# **EASTERN DISTRIBUTOR CITY OF SYDNEY**

## **ENVIRONMENTAL IMPACT ASSESSMENT REPORT**

**NOVEMBER, 1985**

Department of Main Roads, New South Wales

**5**  
**MODIFIED LAYOUT FOR STAGE 2 NORTH OF WILLIAM STREET**

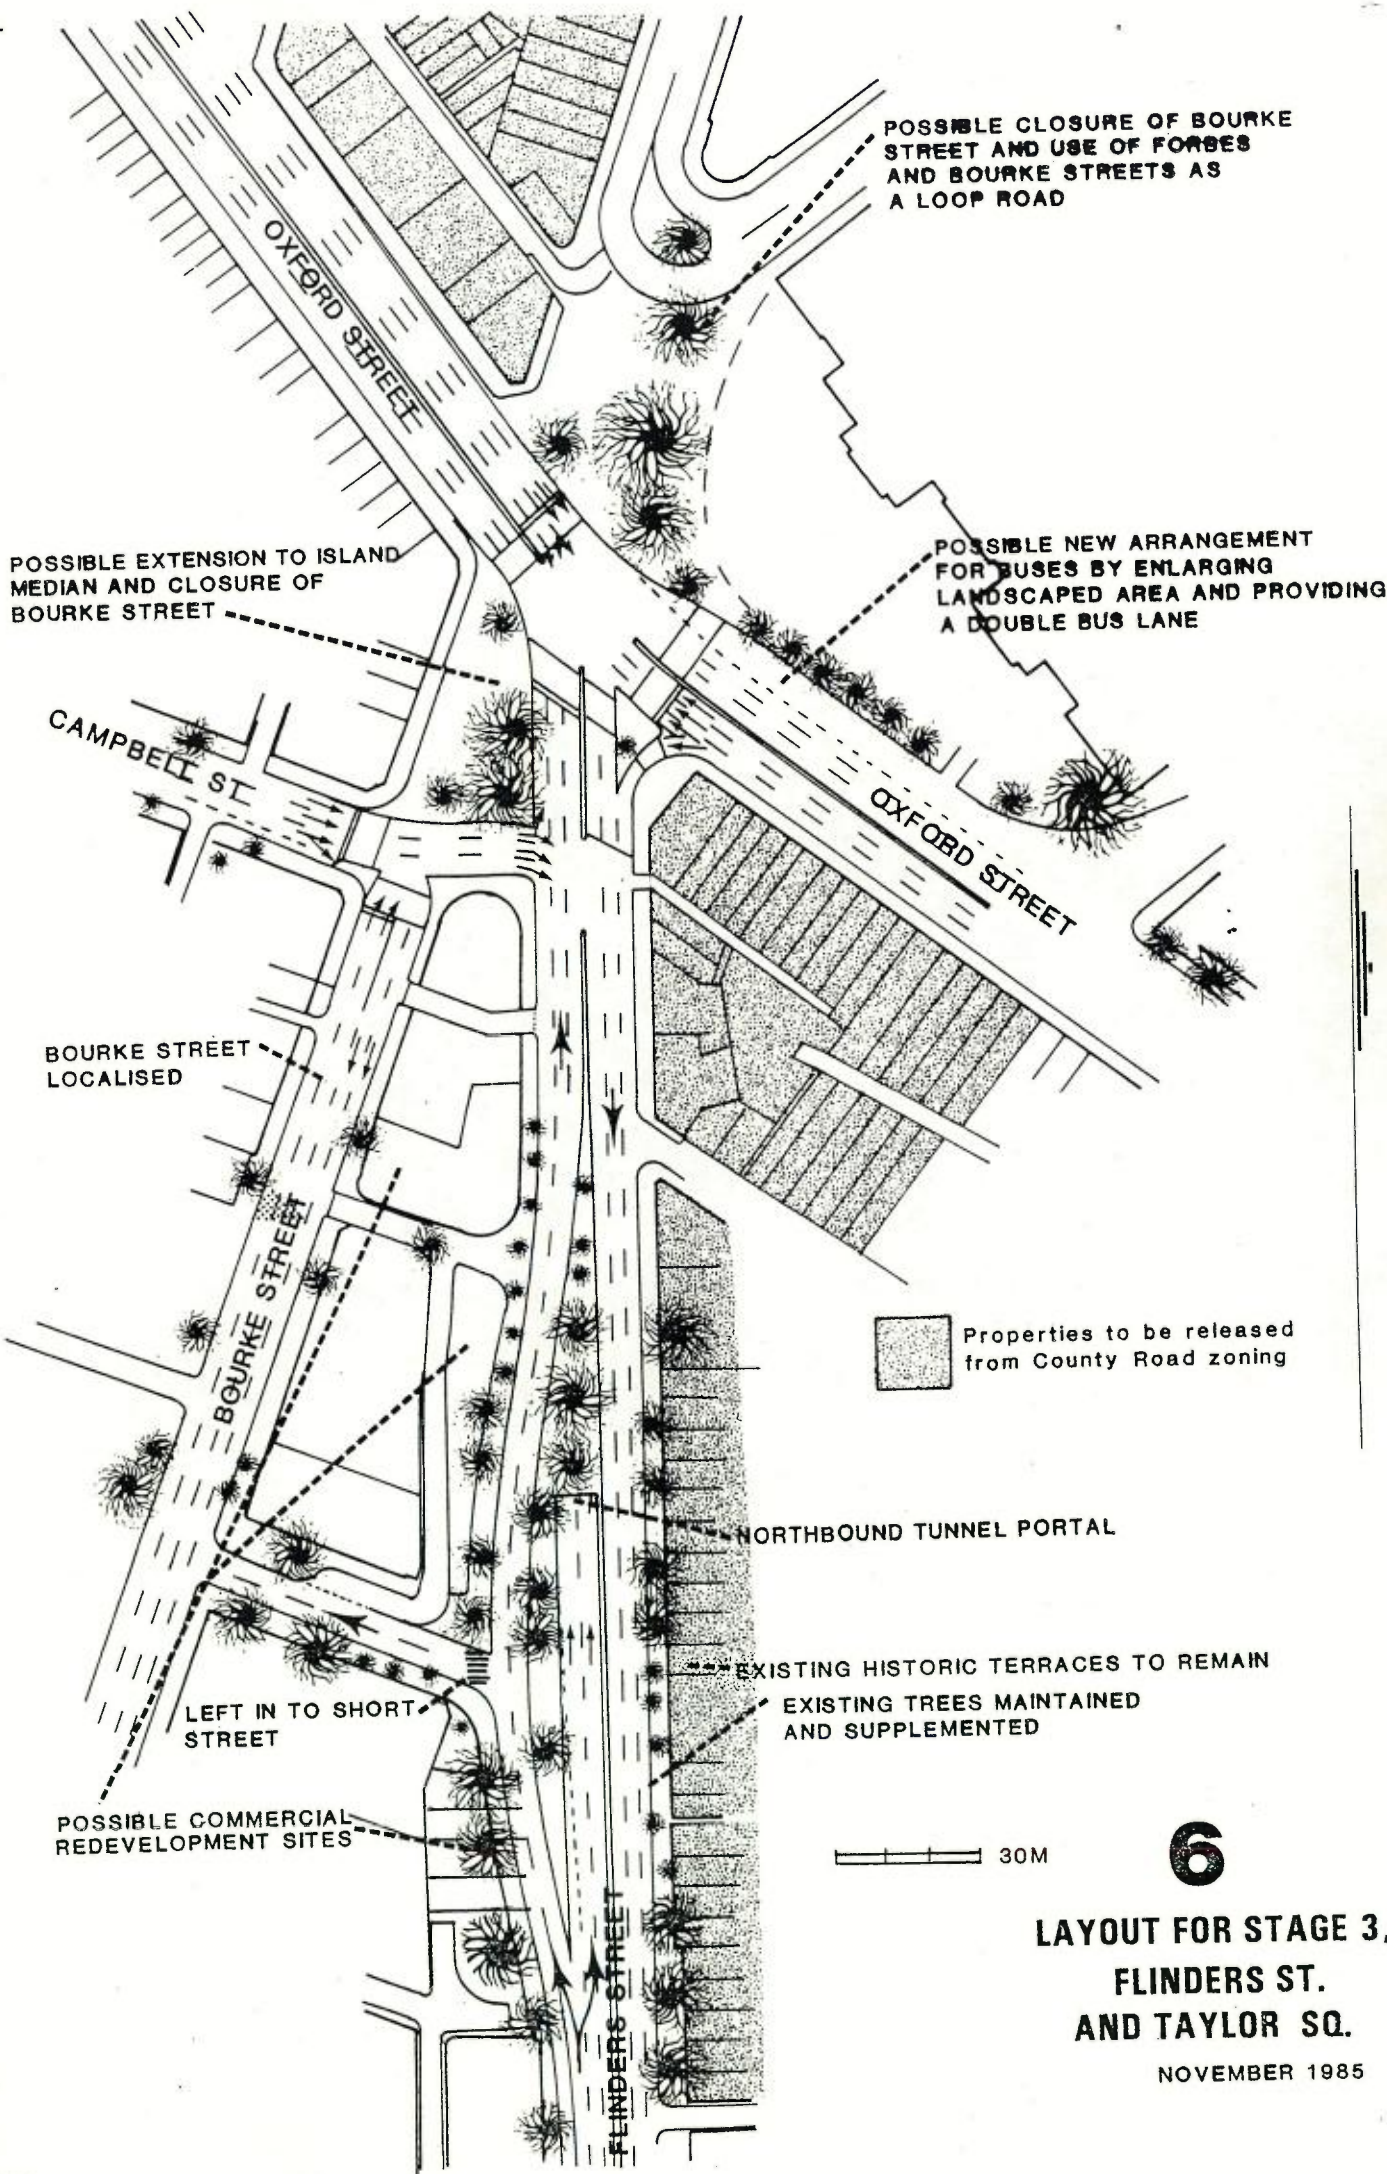
#### 2.3.4 Delroy Flats (Figure 5 of this report)

## LAYOUT FOR STAGE 3, FLINDERS ST. AND TAYLOR SQ.

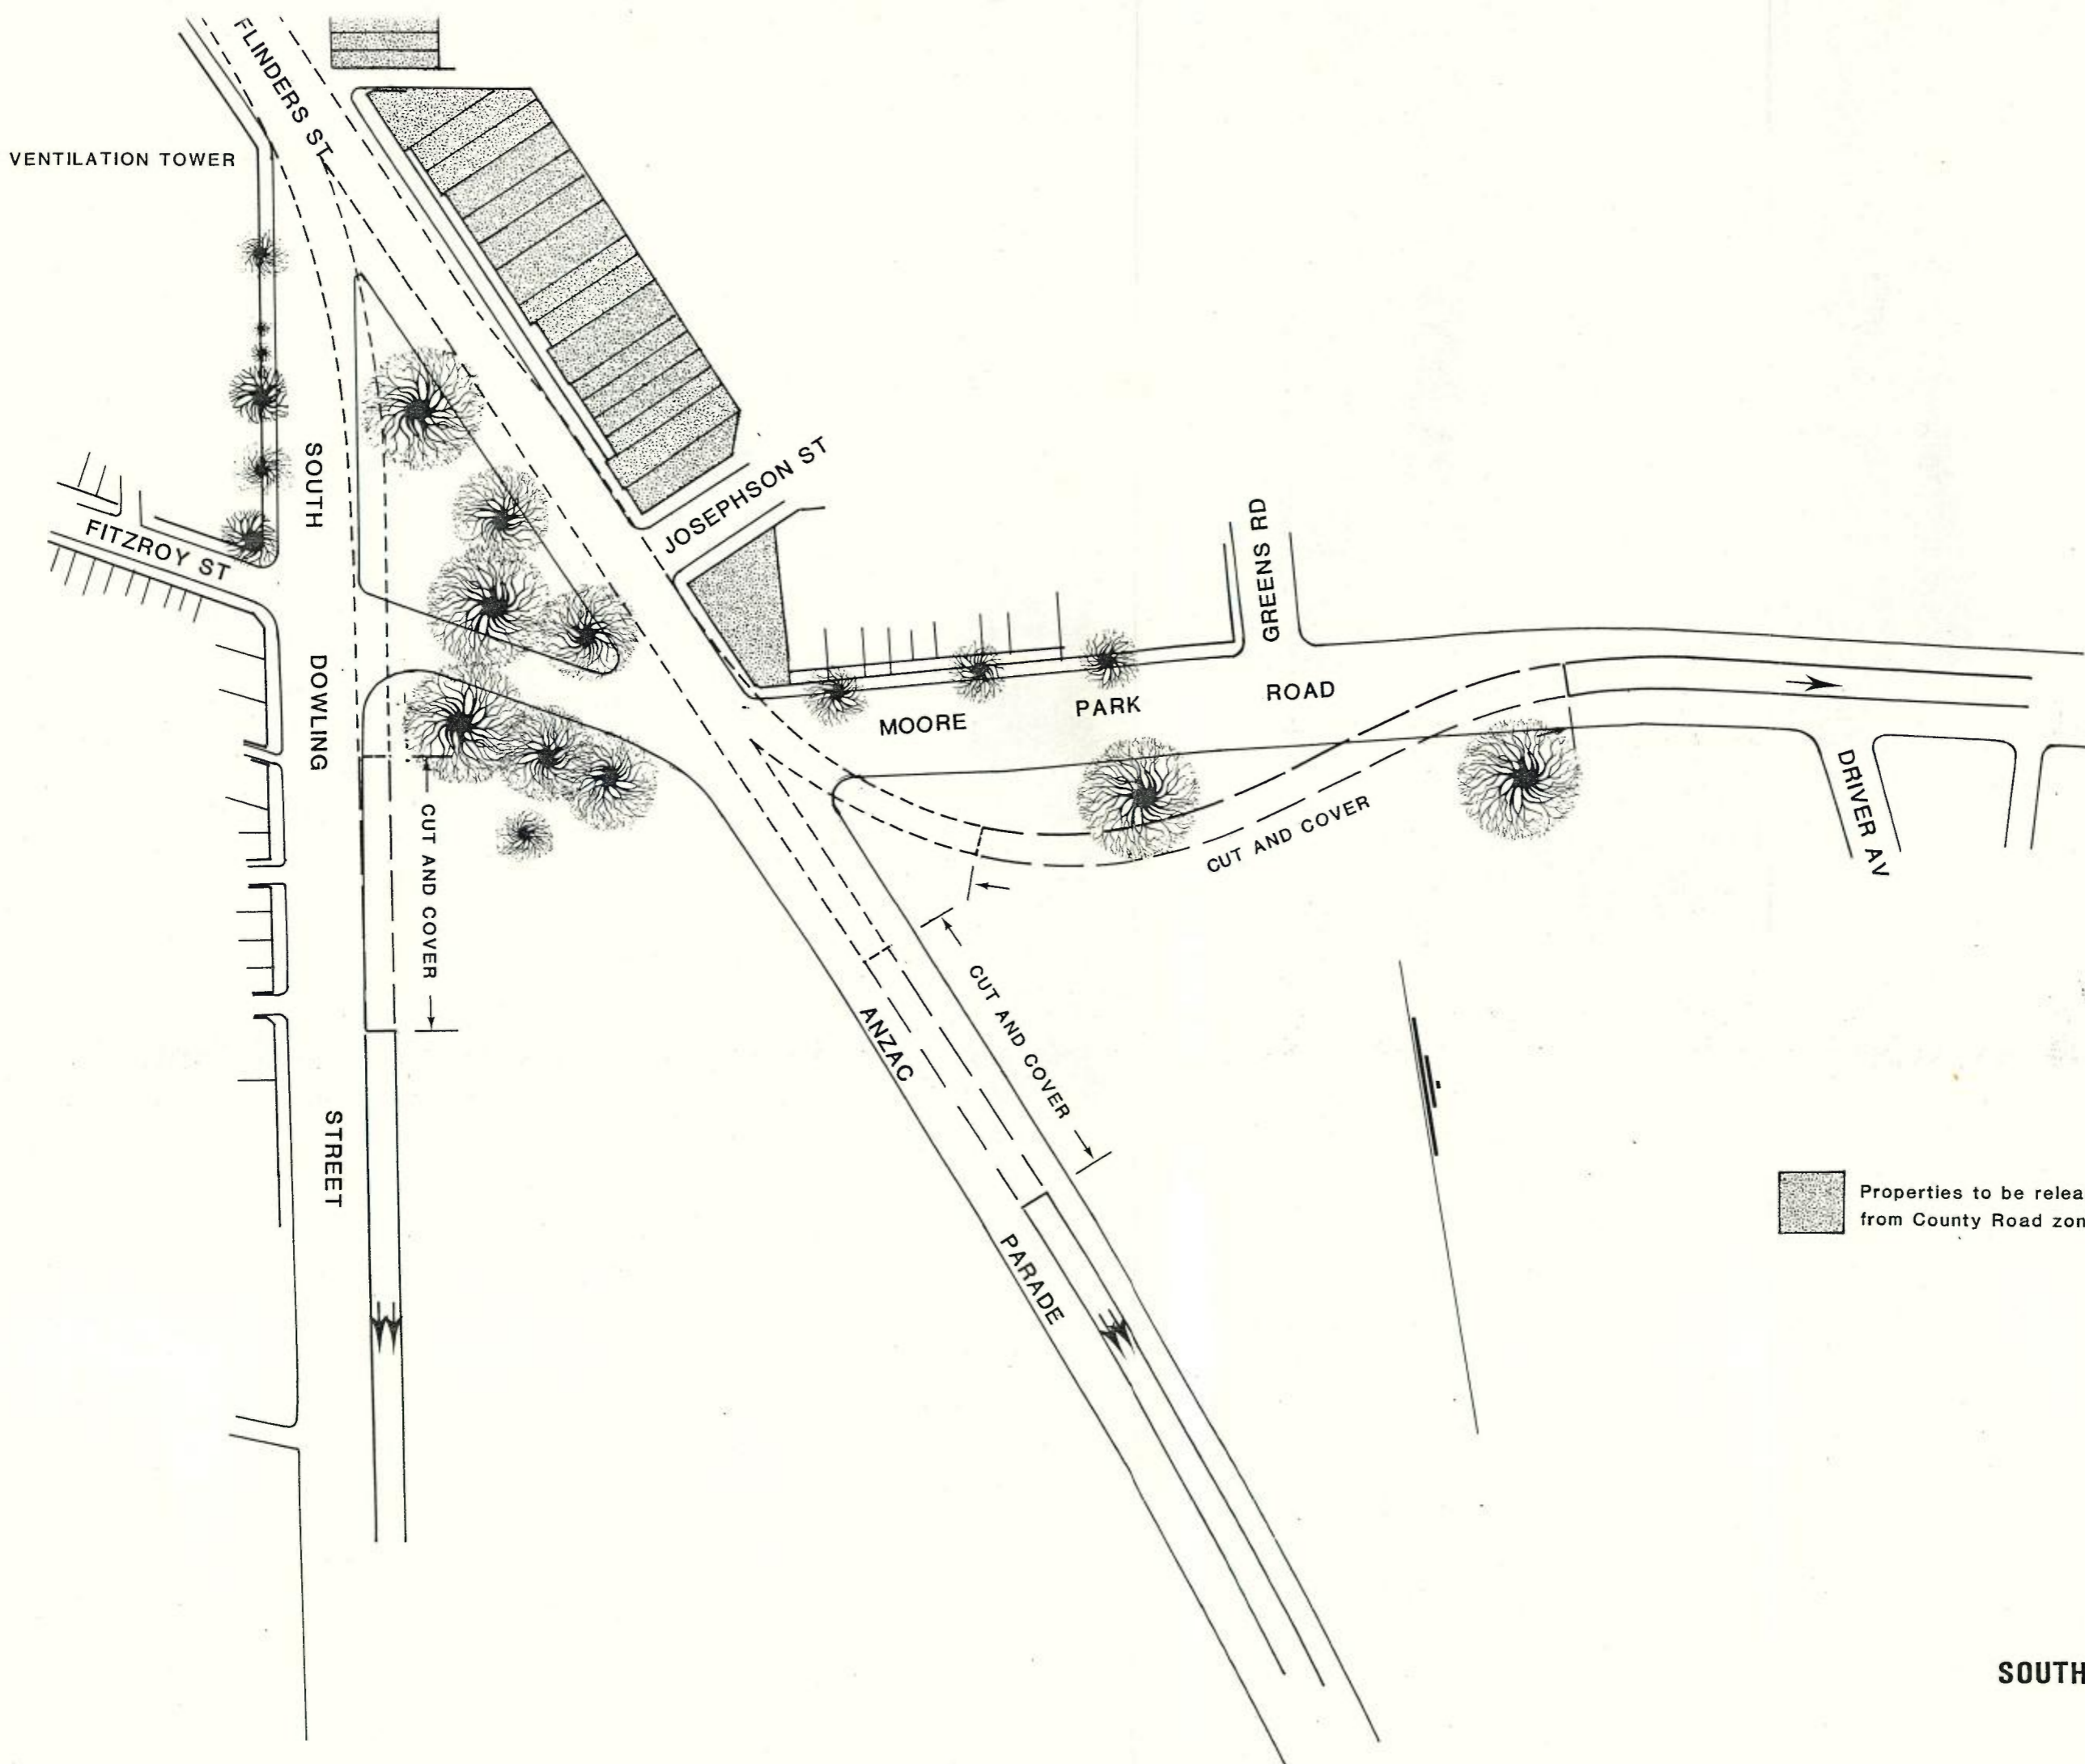
#### 2.3.6 Possible Closure of Bourke Street (Figure 6 of this report).

**NARROW MEDIAN OPTION FOR SOUTH DOWLING STREET**  
(TYPICAL LAYOUT, PHELPS ST TO MADDISON ST.)

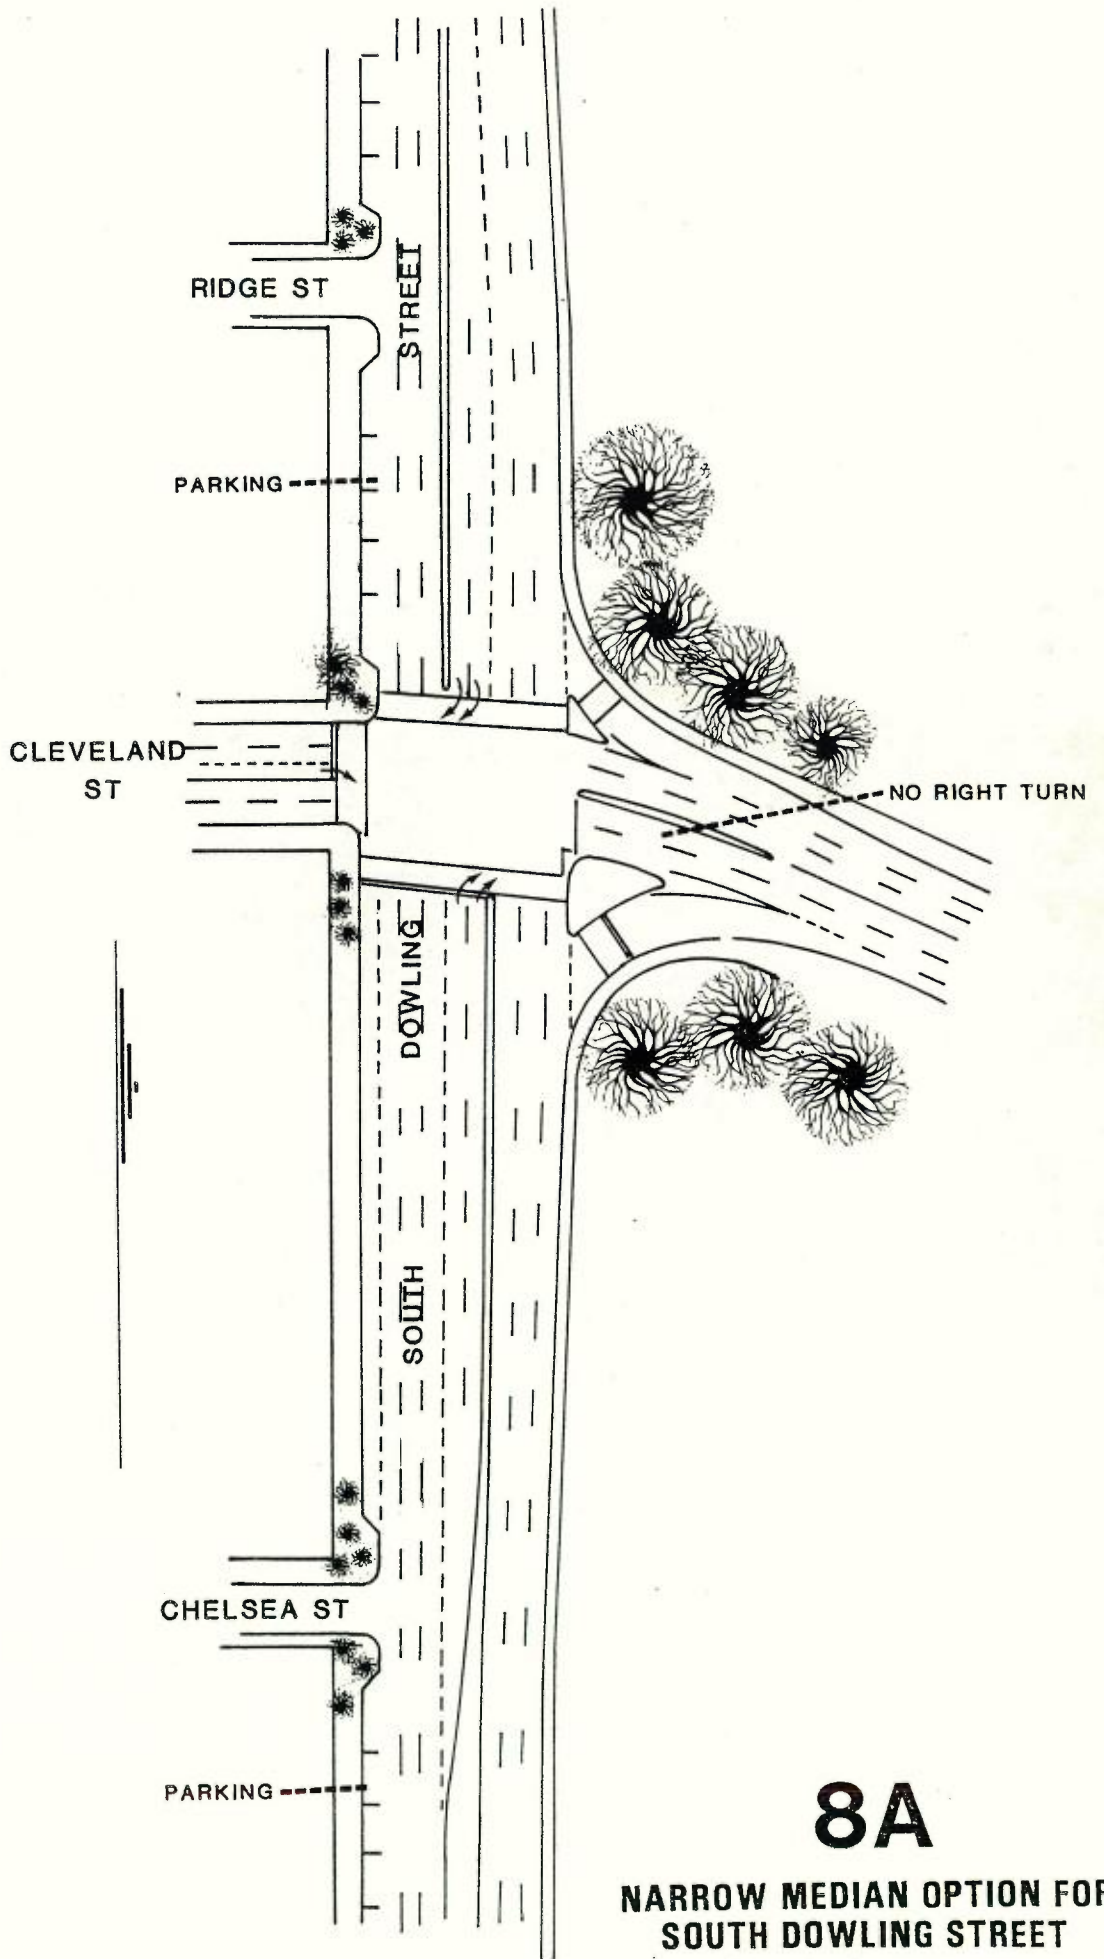
The first option for modification is to shift the northbound carriageway 2.5 metres to the east, and to reduce the median strip by an equal width (see Figure 8). The existing kerbside lane would be treated with footpath widening/tree planting in part, with parking on the remainder. The parking parts could be paved with blocks to extend the visual improvements of the tree planting. This modification would reduce the predicted noise increase of 2 dBA at the building facade by 1.2 dBA, ie existing noise levels of 76 dBA would increase to 76.8 dBA with this modification, compared with 78 dBA if South Dowling Street were unaltered (L10 18 hour noise levels).

**NARROW MEDIAN OPTION FOR  
SOUTH DOWLING STREET  
(TYPICAL LAYOUT,  
PHELPS ST TO MADDISON ST.)**

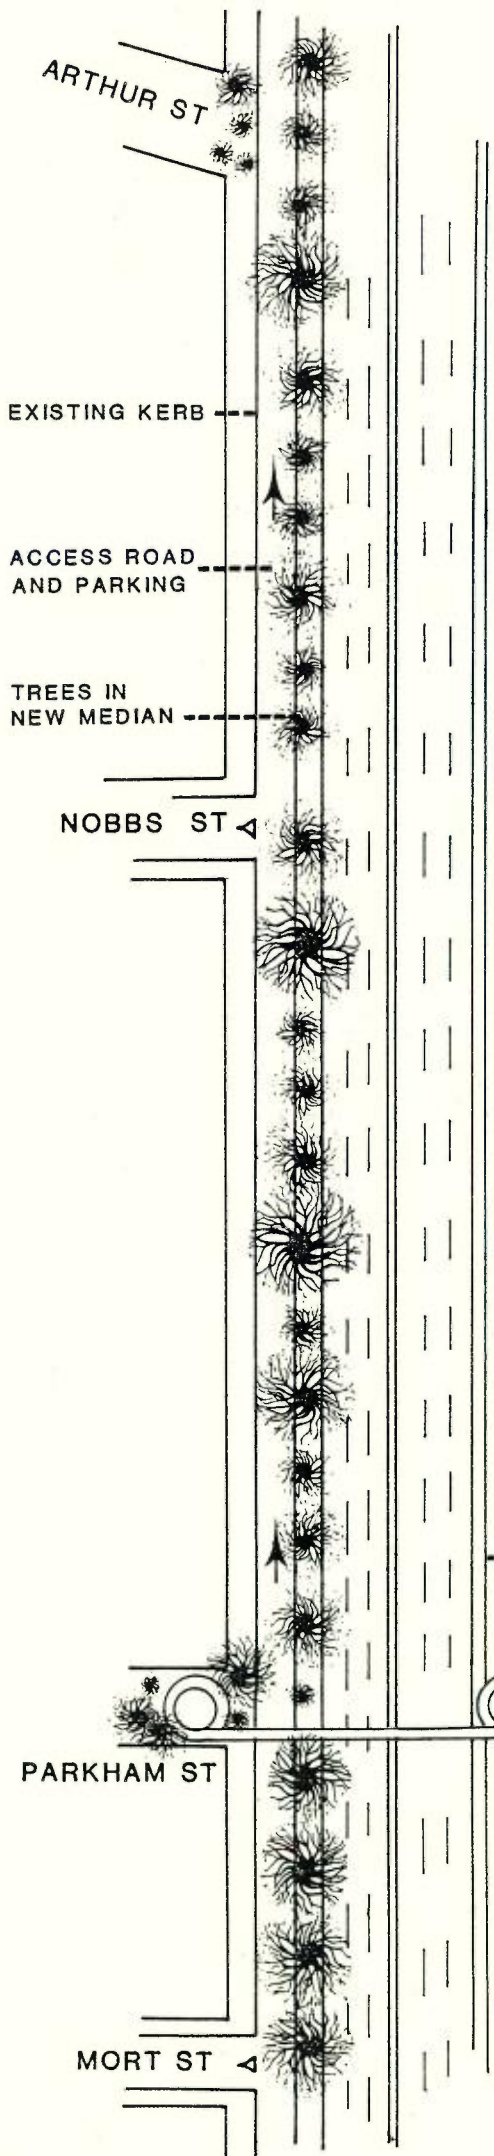
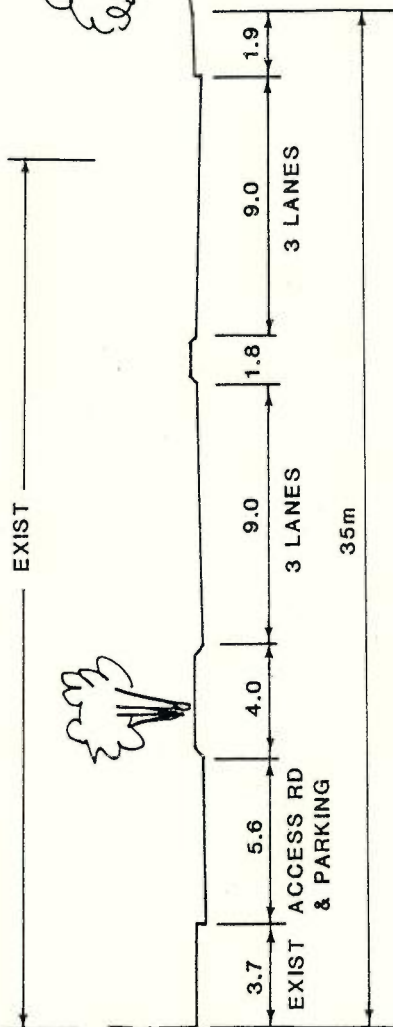
The second option for modification is to shift both carriageways to the east by intruding into Moore Park by about 5 to 8 metres, and to provide an access road along the western side. As shown in Figure 9, a 4 metre wide median would be provided between the access road and the through carriageway. This separation would alter the future noise levels at building facades from an increase of 2 dBA to a reduction of 2 dBA below existing levels. The adverse impact of this scheme would be the loss of 5 to 8 metres of Moore Park, although the new median between the access road and the through carriageway could be planted with trees, and in due course an attractive avenue of trees could develop. This scheme would cost about \$3M more than the first option.
